Centennial Mannering's application to mine beneath the Mannering Creek Ash Dam within the Mannering Creek Notification Area: Mannering-4

Recommendations to the Minister in respect of Mining in the Mannering Creek Notification Area

PROPOSED WORKINGS (BOTH SEAMS) INSIDE THE
MANNERING CREEK ASH DAM NOTIFICATION AREA

Manning Colliery's application to mine within the Manning Creek Notification Area: DSC designation MANNERING-4

MG 1560

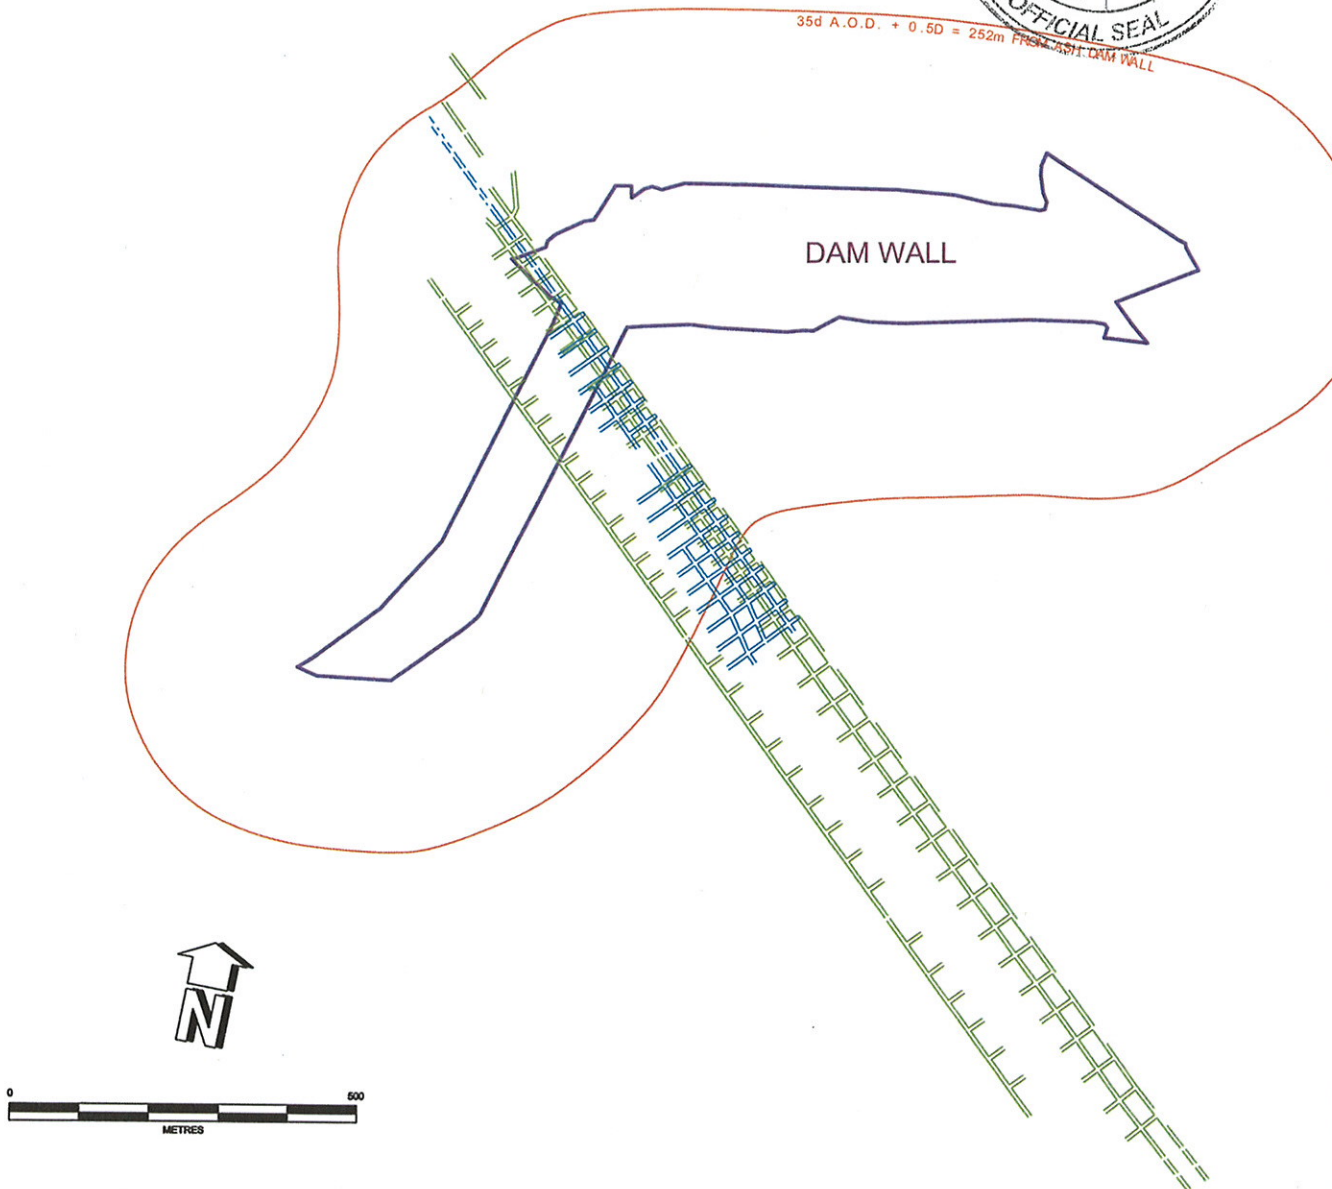
- This approval is for the first workings outlined in green and blue.
- This approval is until the 31st December 2015.

1. That approval to conduct first workings within the notification area as depicted on the attached plan, MG1560 dated 28/9/2011 and outlined in green and blue, be approved subject to conditions 1, 2, 3, 4, 5, 8, 10, 11, 12, 13, 15, 19, 20, 22, 23 and 24 of the attached Annexure D, and condition 1, of Annexure D1.

PLAN No
MG 1560

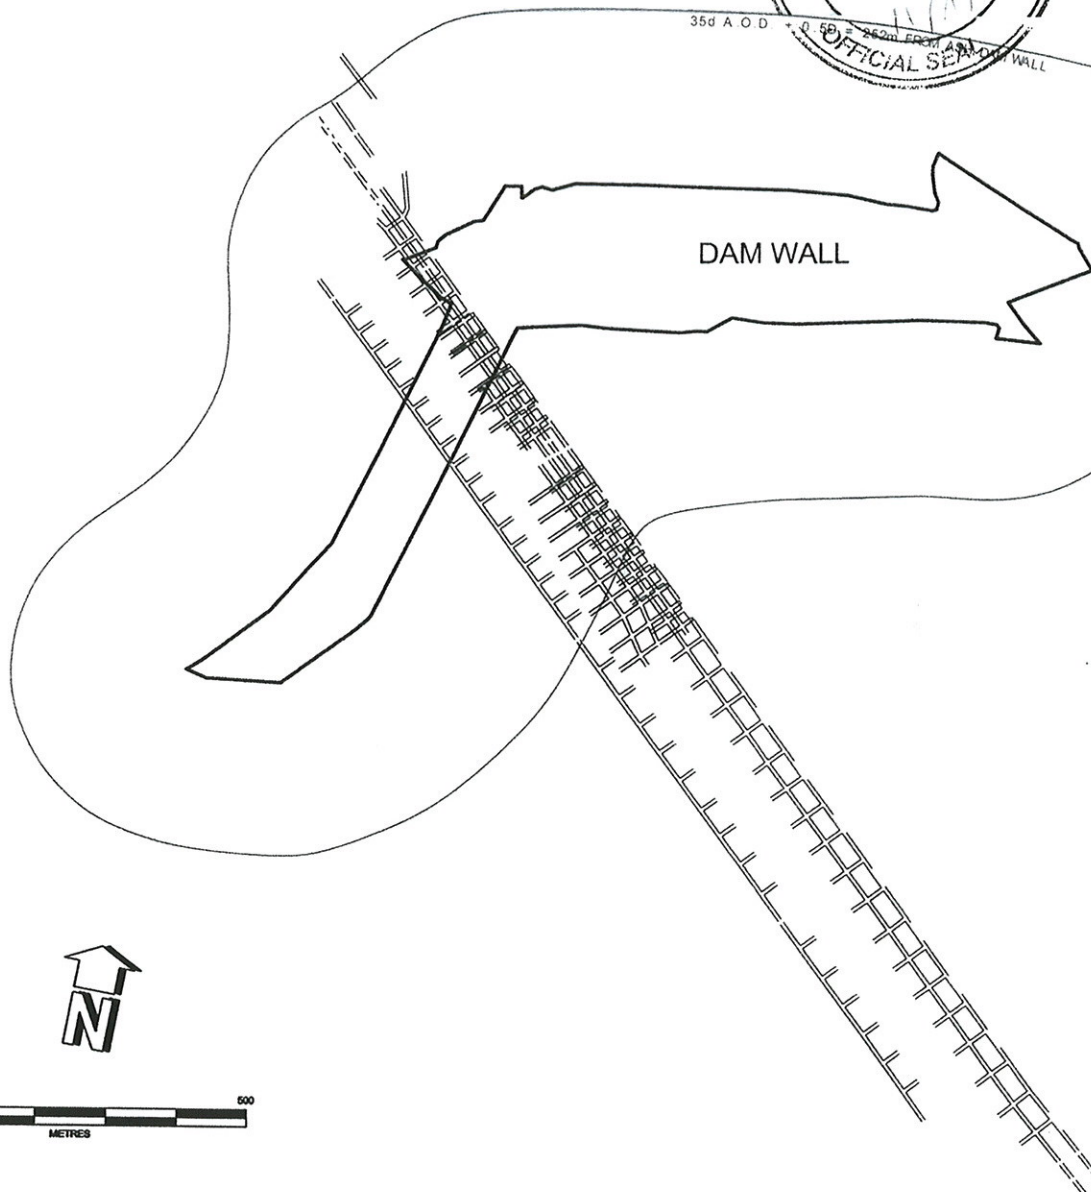
- This approval is for the first workings outlined in green and blue.

This approval is until the 31st December 2015.
